Access Compliance Report Public Rights-of-Way (Curb Ramps)

Main Street: FILLMORE_DR		Cross Street: NEARING_DR		Location:	NW
ADA ID: RPAT211124140933	Ramp Type: Type 4 - Parallel	Initial Pass/Fail: Fail	Overall Compliance: No	Severity Score:	15
Codes/Mitigation Info/Possible Solution			Field Measurements/Component Compliance

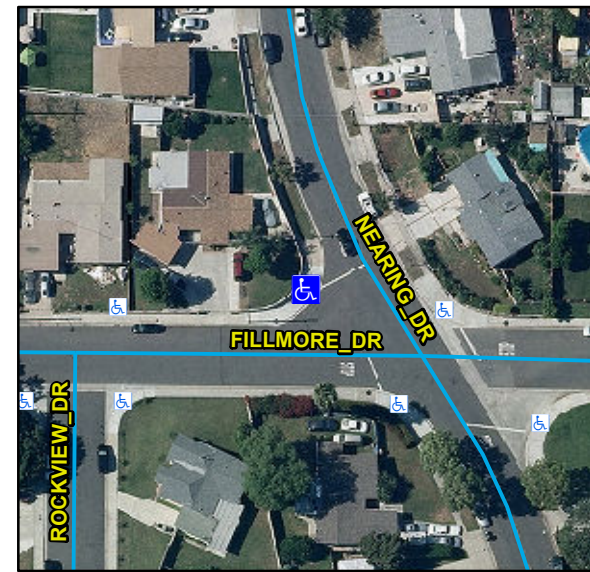
Compliance	Description	Data	Compliance	Description	Data
N/A	Ramp Length LT (in)	110	N/A	Ramp Length RT (in)	105
Yes	Ramp Width LT (in)	53	Yes	Ramp Width RT (in)	53
Yes	Ramp Run Slope LT (%)	4	Yes	Ramp Run Slope RT (%)	3.1
No	Ramp Cross Slope LT (%)	6.8	No	Ramp Cross Slope RT (%)	6.7
N/A	Landing Present	N/A	N/A	DWS Provided	N/A
N/A	Landing Length (in)	N/A	N/A	DWS Contrast	N/A
N/A	Landing Width (in)	N/A	N/A	DWS Length (in)	N/A
N/A	Landing Run Slope (%)	N/A	N/A	DWS Full Width	N/A
N/A	Landing Cross Slope (%)	N/A		DWS Offset Type	N/A
N/A	Landing Movement Obstructed?	N/A	N/A	DWS Offset Left (in)	N/A
	Landing Movement Type	N/A	N/A	DWS Offset Right (in)	N/A
N/A	Landing Shared	N/A			
N/A	Clear Space	Yes			
N/A	Clear Space To Crosswalk (in)	N/A			
N/A	Marked Crosswalk 1	No	N/A	Marked Crosswalk 2	No
	Crossing 1 Direction	S		Crossing 2 Direction	E
	Marked Crosswalk 1 Width (in)	N/A		Marked Crosswalk 2 Width (in)	N/A
N/A	Ramp Inside Crosswalk 1	N/A	N/A	Ramp Inside Crosswalk 2	N/A

Remove & Replace Curb Ramp With Two New Directional Ramps or Equivalent.

R304.2.2, R304.5.3, STD 1115
